**CITY OF LOUISVILLE
STARK COUNTY, OHIO**

METZGER PARK BASEBALL & SOFTBALL FIELDS

ADDENDUM #4

September 25, 2023

FENCE DETAIL

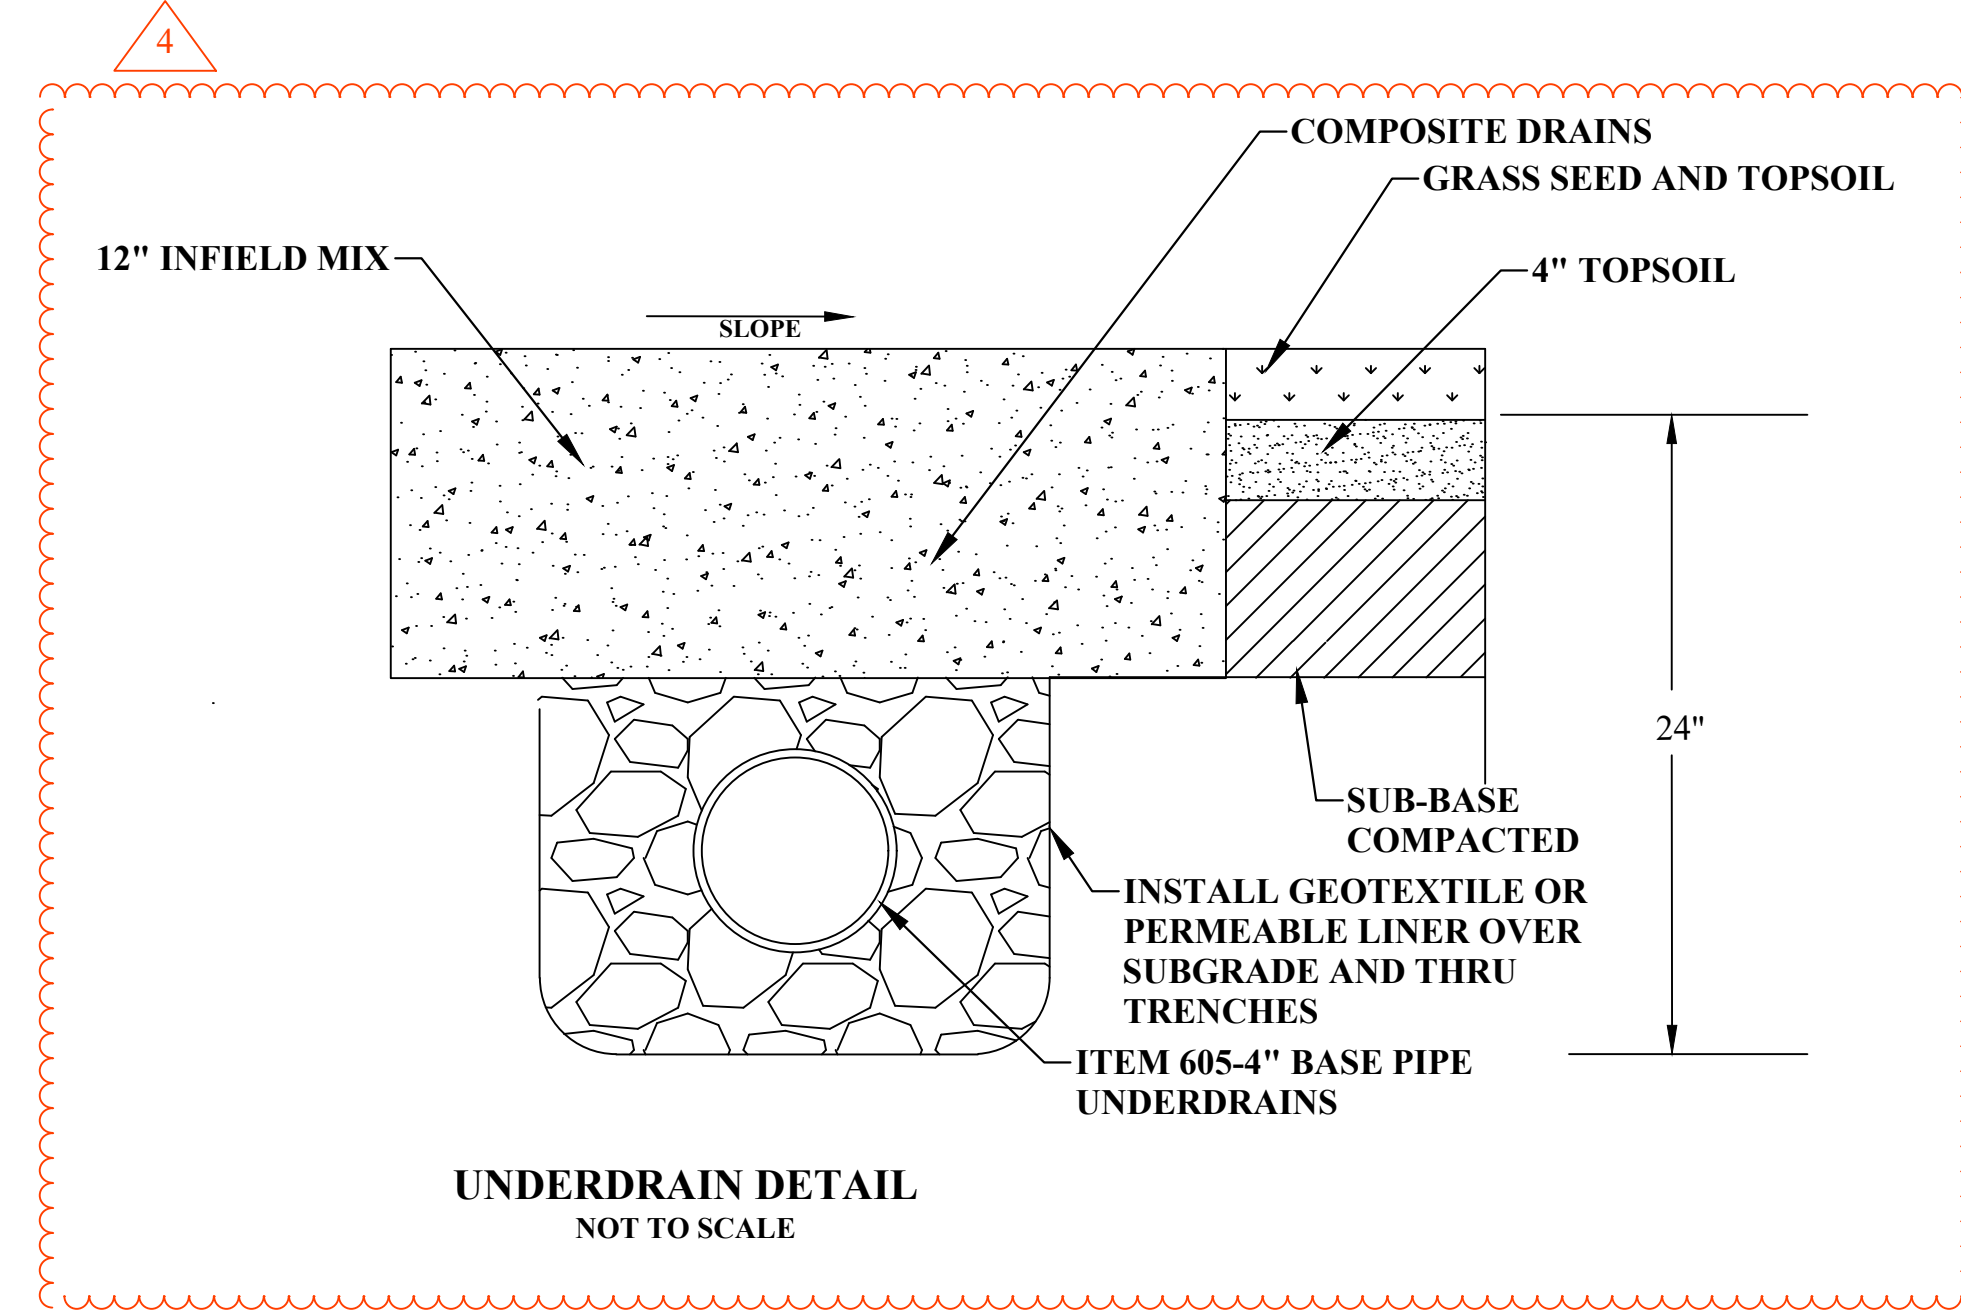
3. There are no details for the 15 ft. high fence at all. What does the owner expect for fence details here?

4. Is the backstop fence height 25 ft?

5. Is the owner's idea for an overlap on the fabric at mid height?

6. All post diameters sizes are not adequate for the height of the backstop.

7. Can we have a complete overhaul of the details on the fence for the 6 ft. sideline, 15 ft. outfield, and the 25 ft. high backstop fence?

Please refer to the revised fence detail on Sheet 26.

The backstop fence height is 15 ft. Please refer to the revised fence detail on Sheet 26.

Please refer to the fence detail on Sheet 26.

Please refer to the fence detail on Sheet 26.

Please refer to the revised fence detail on Sheet 26.

UNDER DRAIN & PLAYERS BENCH DETAIL

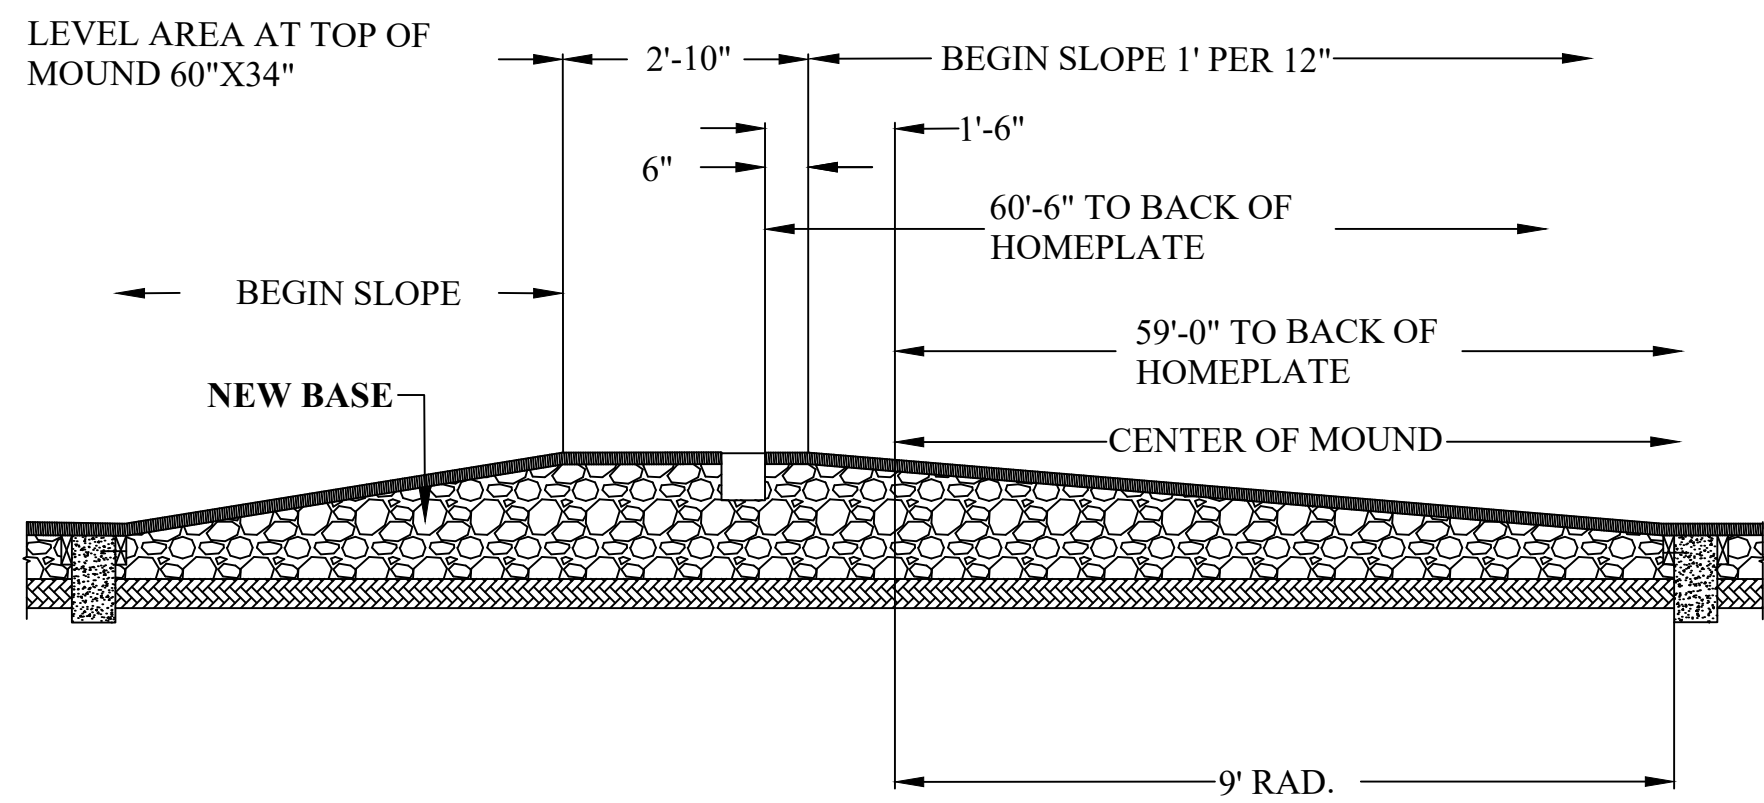
13. On Sheet 32, Note 2 it refers to nailer installed around the perimeter of the infield. Please provided a detailed drawing of this nailer that is being called out.

14. Sheet 32 refers to the infield mix. Please provide a spec for the required infield mix.

15. Sheet 32, Note 7 refers to a rubber infield. Please clarify.

16. On Sheet 32, please provide details and specification for the type of stone required for this item.

Sheet 32 has been revised. Note 2 has been removed.

The infield mix is to be S&S Processing Fielder's Choice Infield Mix or similar product from Dura Edge Engineered Soil, Sure-Hopo Infield Mix, or approved equal.

Sheet 32 has been revised. Note 7 has been removed.

Detail updated to call out 4" base pipe underdrain.
